802.16e™

# Part 16: Air Interface for Fixed and Mobile Broadband Wireless Access Systems

## Amendment 2: Physical and Medium Access Control Layers for Combined Fixed and Mobile Operation in Licensed Bands

**IEEE Std 802.16e™-2005** *and*
**IEEE Std 802.16™-2004/Cor1-2005**
(Amendment and Corrigendum to
IEEE Std 802.16-2004)

**Figure 95—Theory of Operation Object Model**

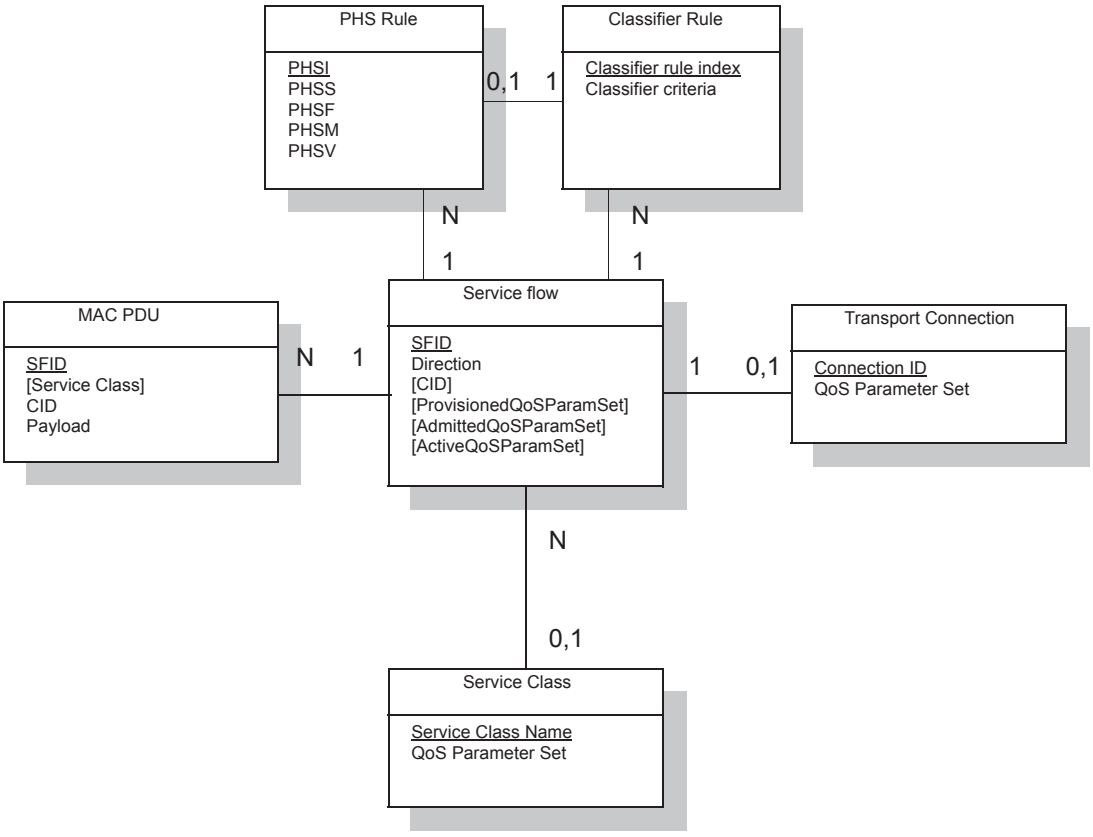
***Replace Figure 95 with the following figure:***

**Figure 130j—Security sublayer**

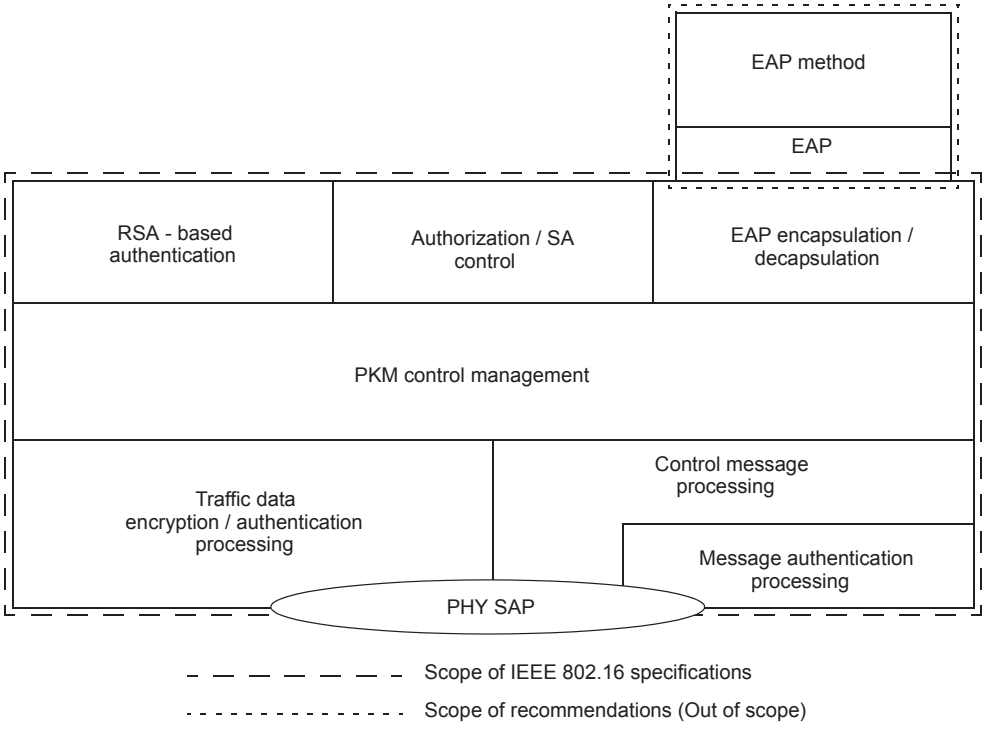
***Insert new figure:***

**Figure 134—TEK management in BS and SS**

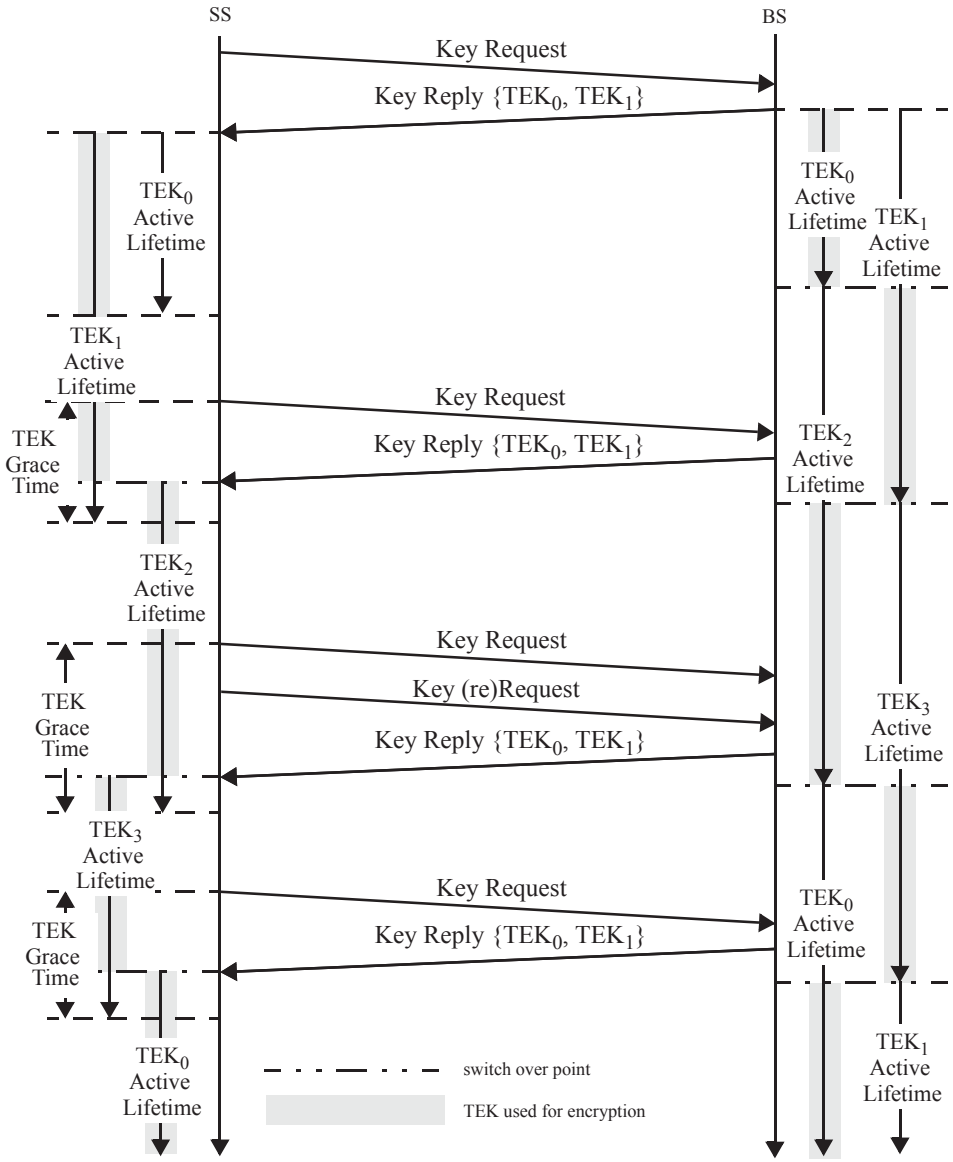
***Replace Figure 134 TEK Management in BS and SS with the following figure:***

**Figure 207—Example of OFDM frame structure with TDD**

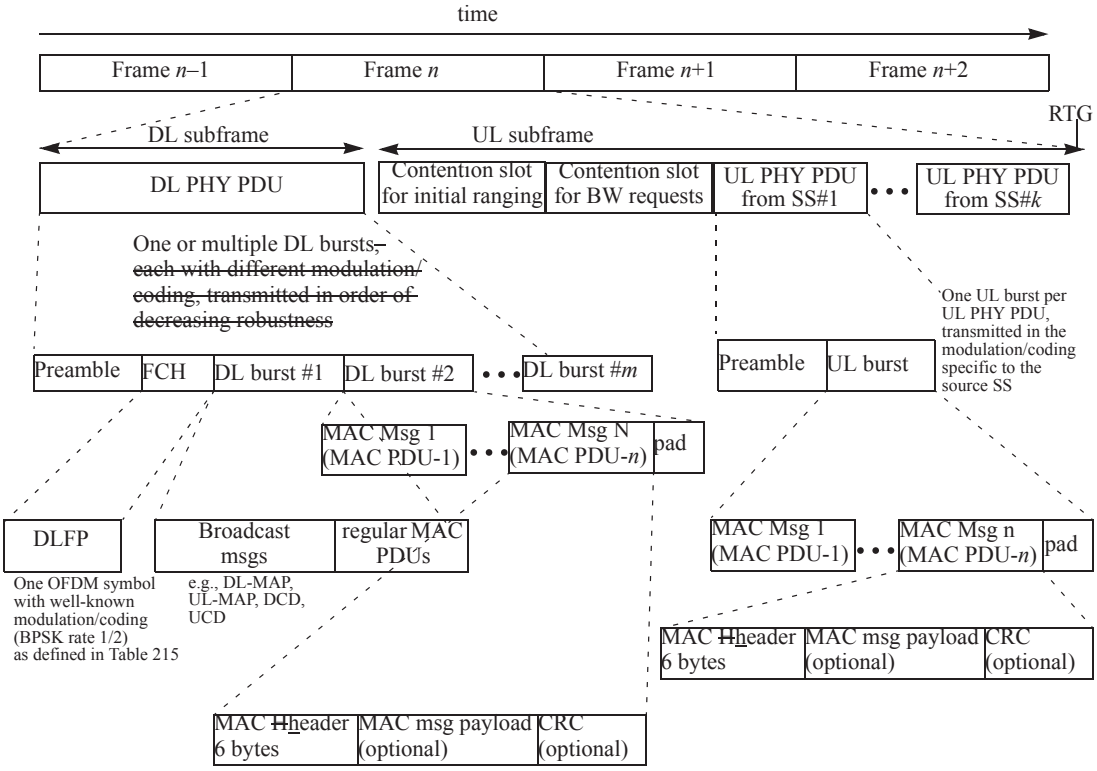
***Change Figure 207 as indicated:***

**Figure 208—Example of OFDM frame structure with FDD**

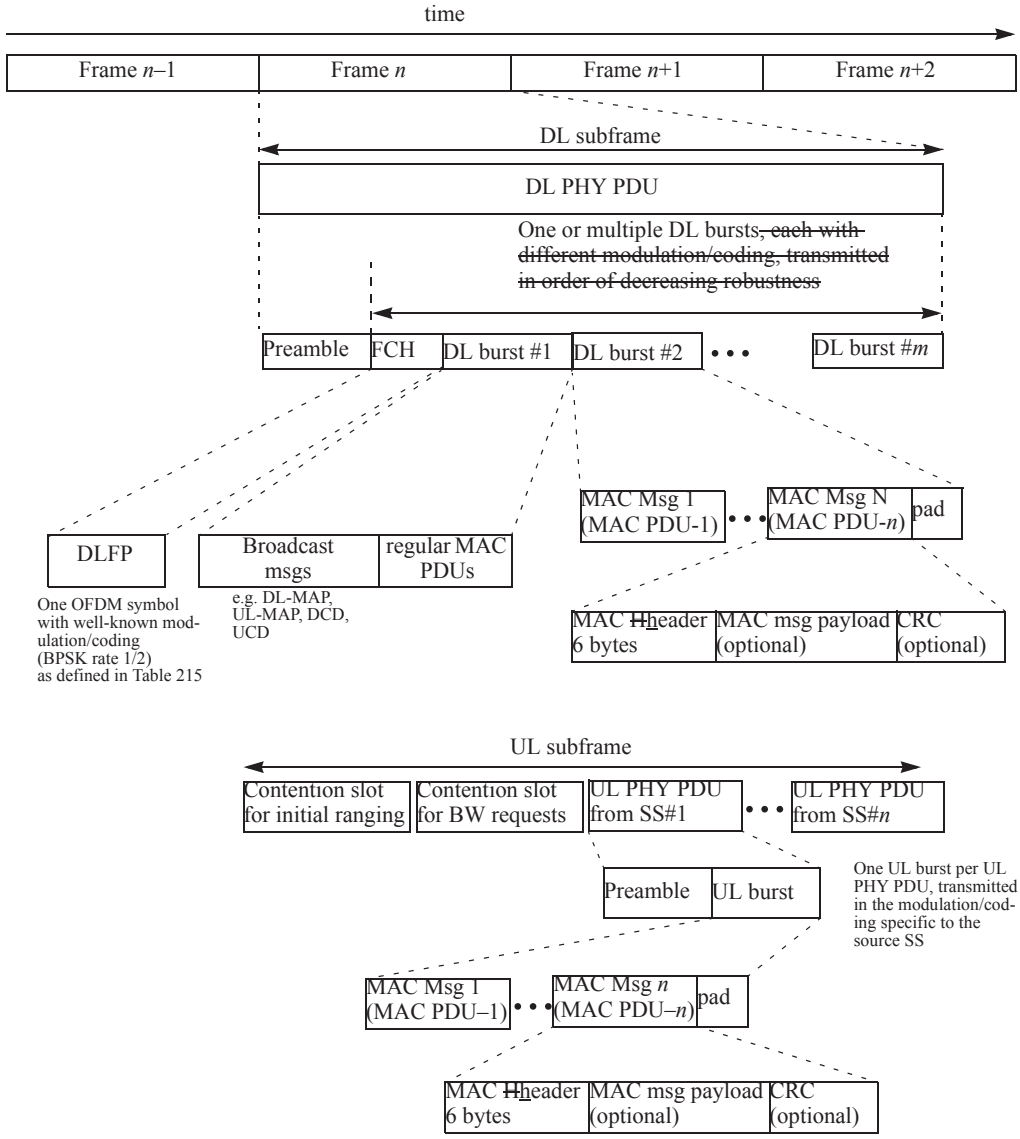
***Change Figure 208 as indicated:***

**Figure 209—Structure of AAS Zone**

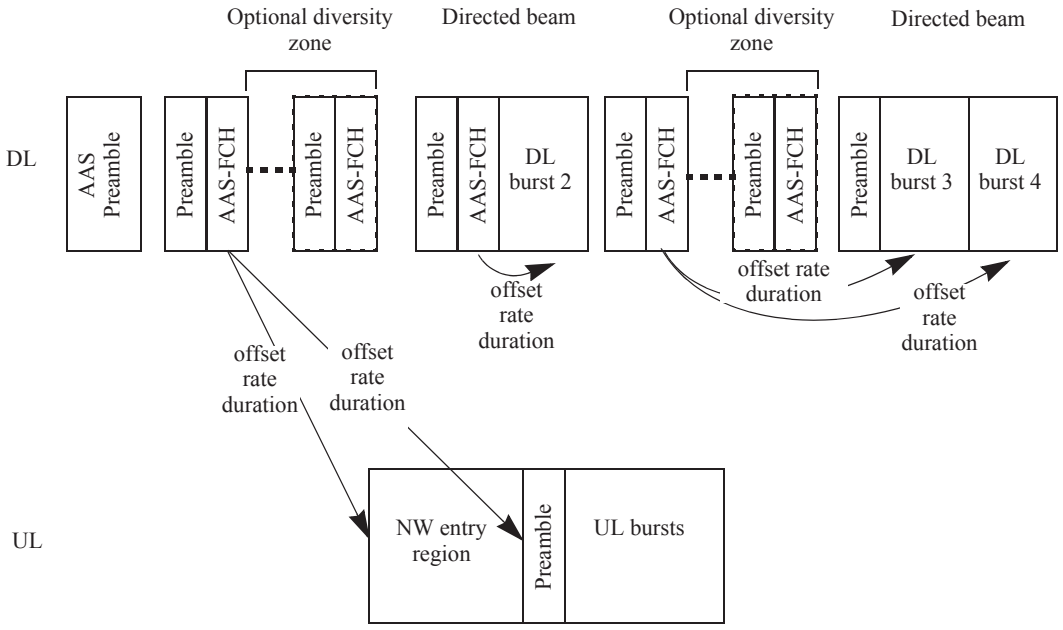
***Replace Figure 209 with the following figure:***

**Figure 216—Example of mapping OFDMA slots to subchannels and symbols in the downlink (in PUSC mode)**

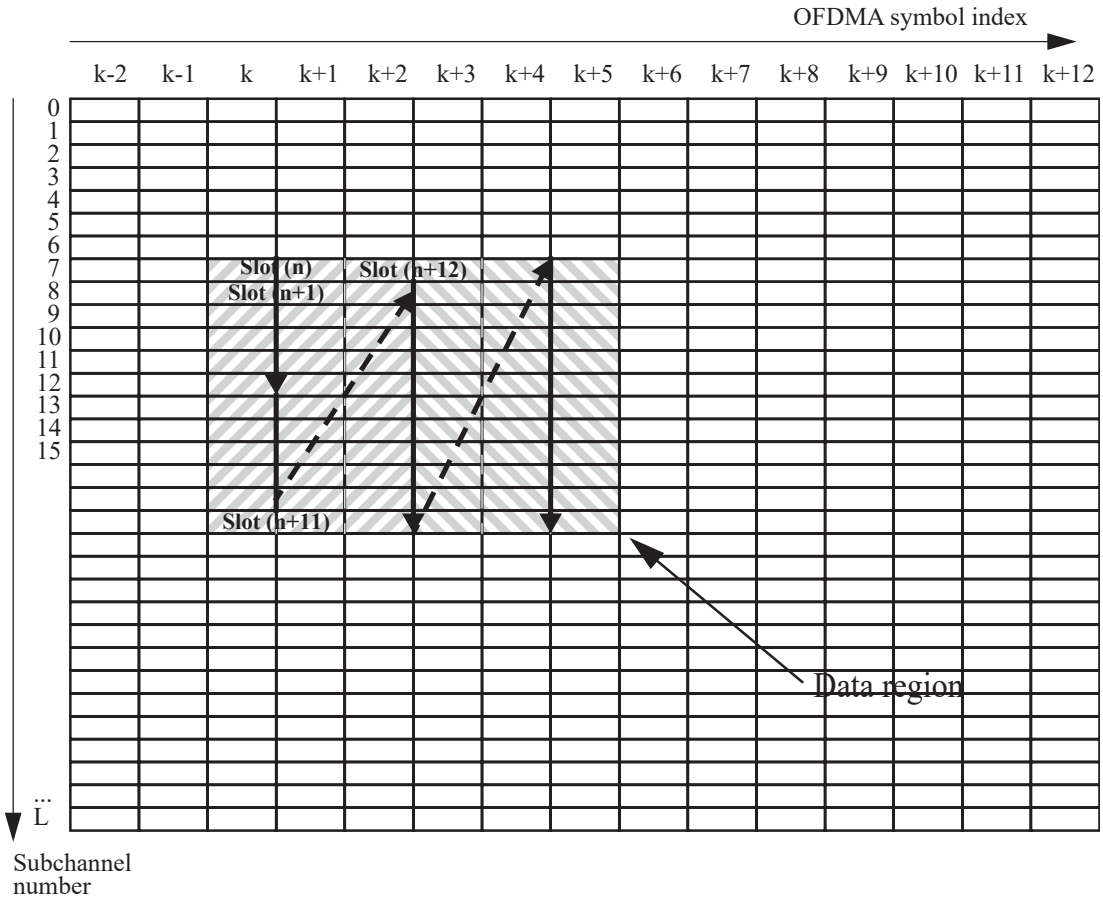
***Replace Figure 216 and Figure 217 with the following figures:***

**Figure 218—Example of an OFDMA frame (with only mandatory zone) in TDD mode**

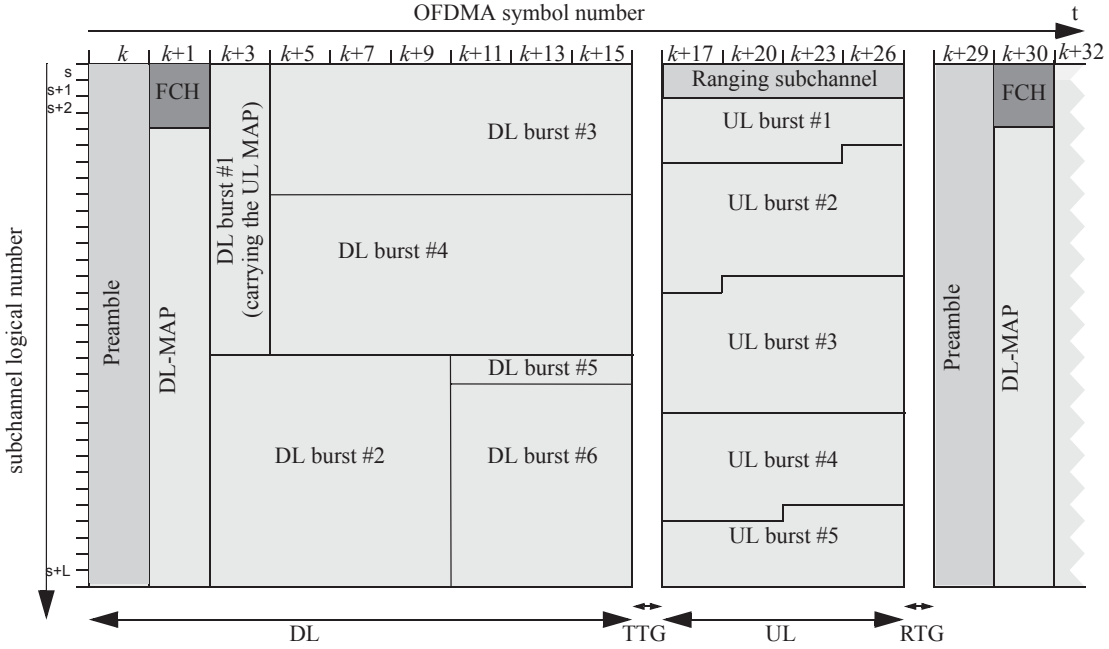
***Replace Figure 218 with the following figure:***

**Figure 219—Illustration of OFDMA frame with multiple zones**

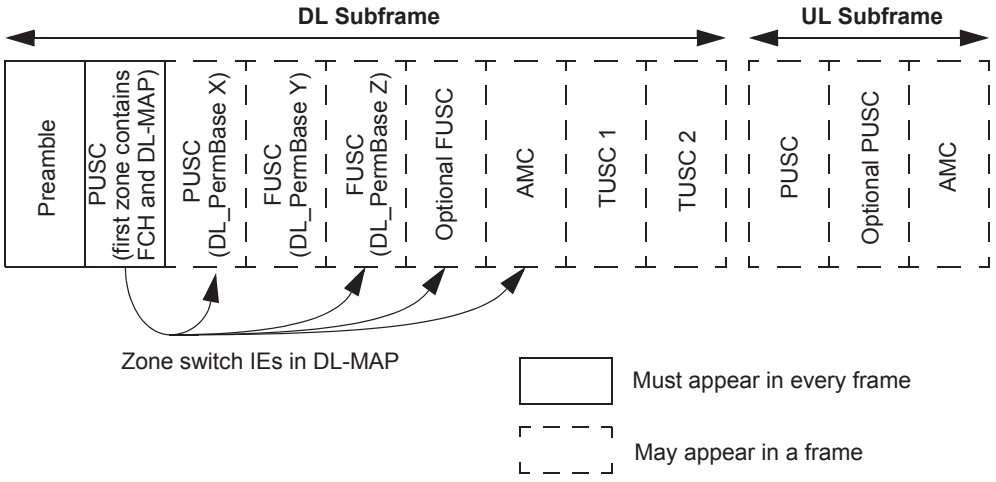
***Replace Figure 219 with the following figure:***

**Figure 230—Mapping order of FAST-FEEDBACK messages to the FAST-FEEDBACK region**

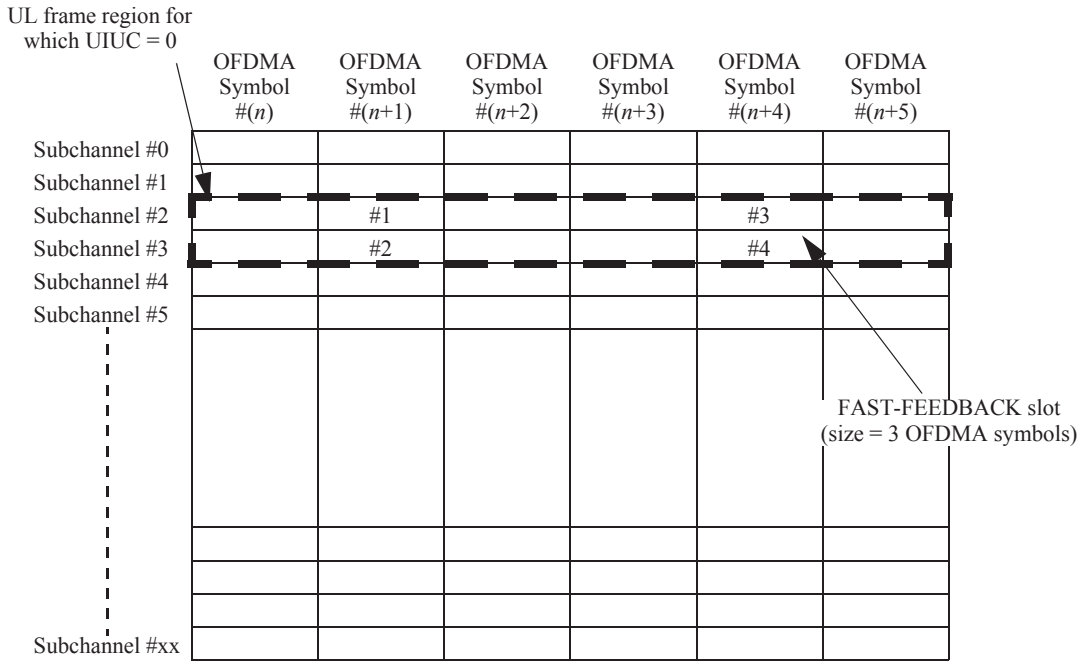
***Replace Figure 230 with the following figure:***

**Figure 245—Cluster structure for STC PUSC using 2 Antennas**

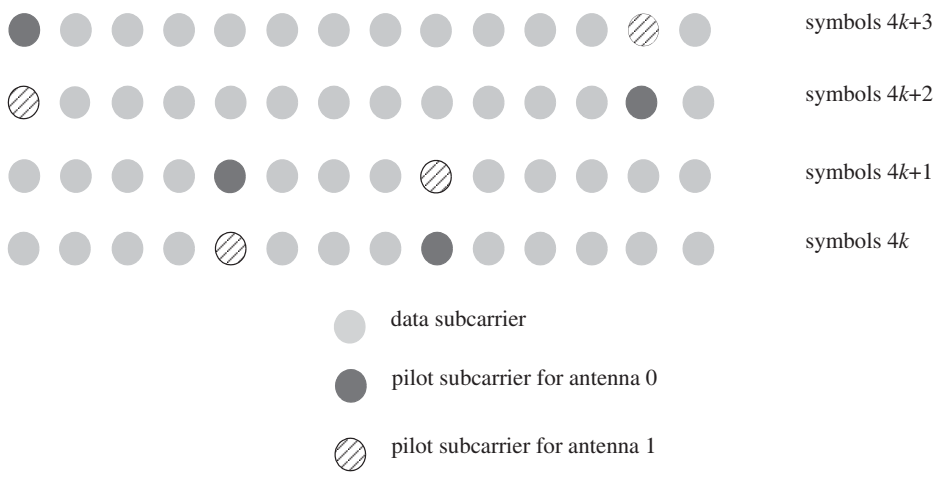
***Replace Figure 245 with the following figure:***

**Figure 247—STC usage with FUSC**

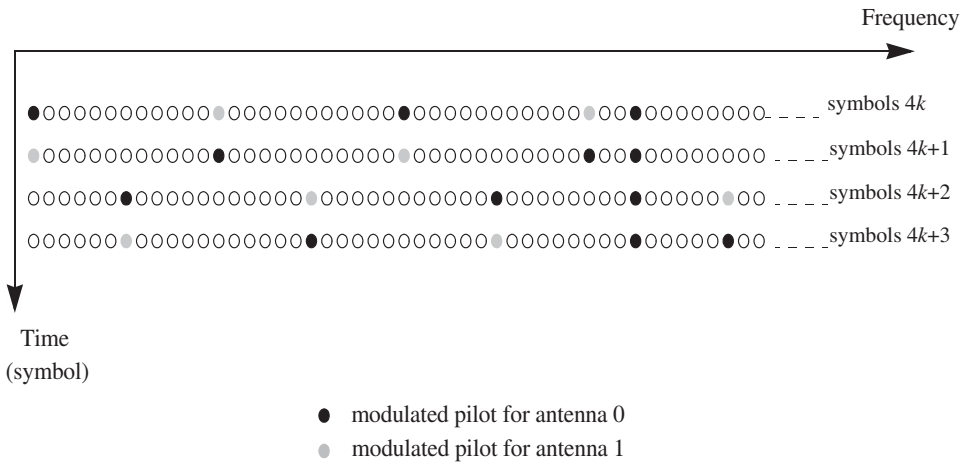
***Replace Figure 247 with the following figure:***

**Figure 251—Cluster structure for STC PUSC using 4 antennas**

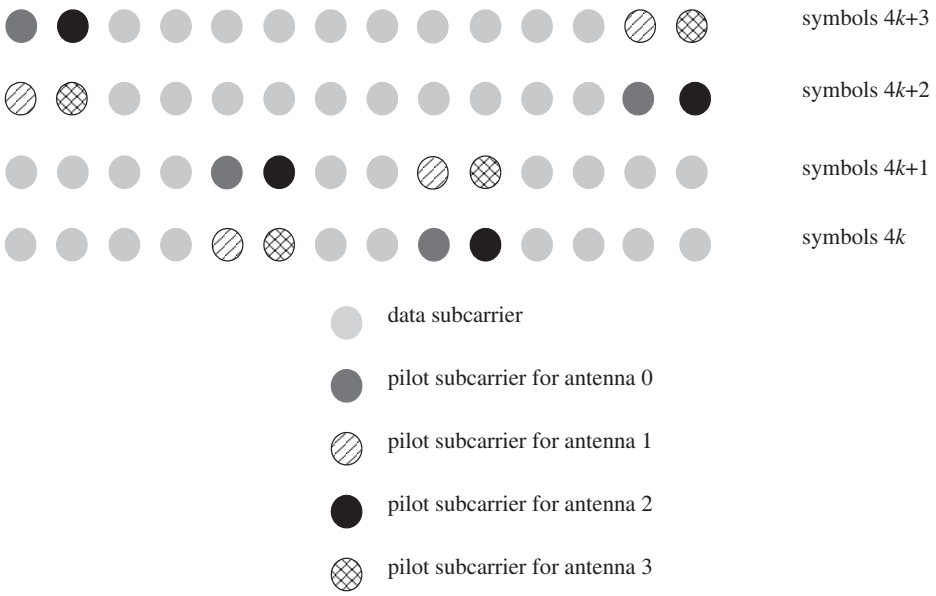
***Replace Figure 251 with the following figure:***

**Figure 251a—STC usage with FUSC**

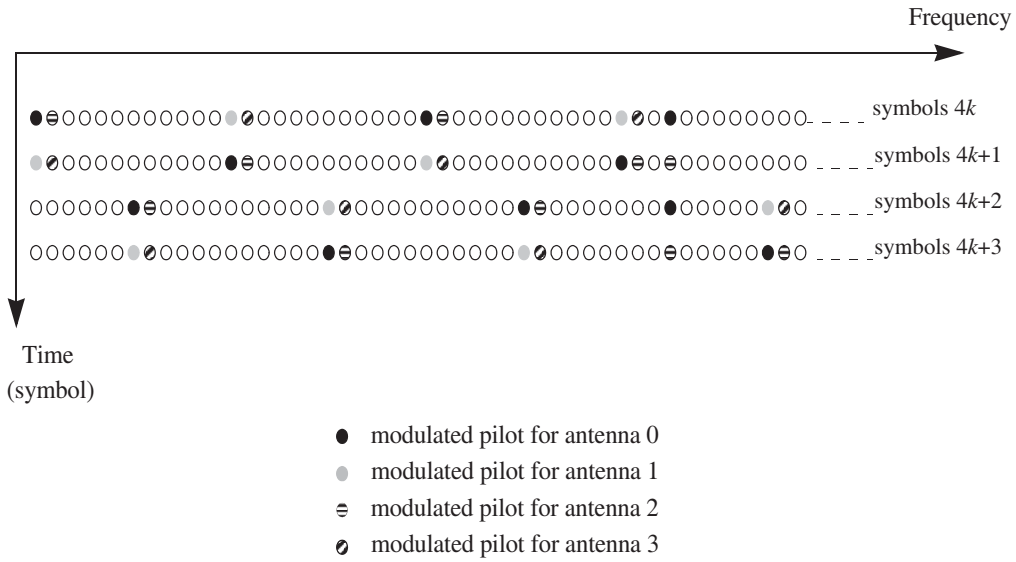
***Insert new Figure 251a:***
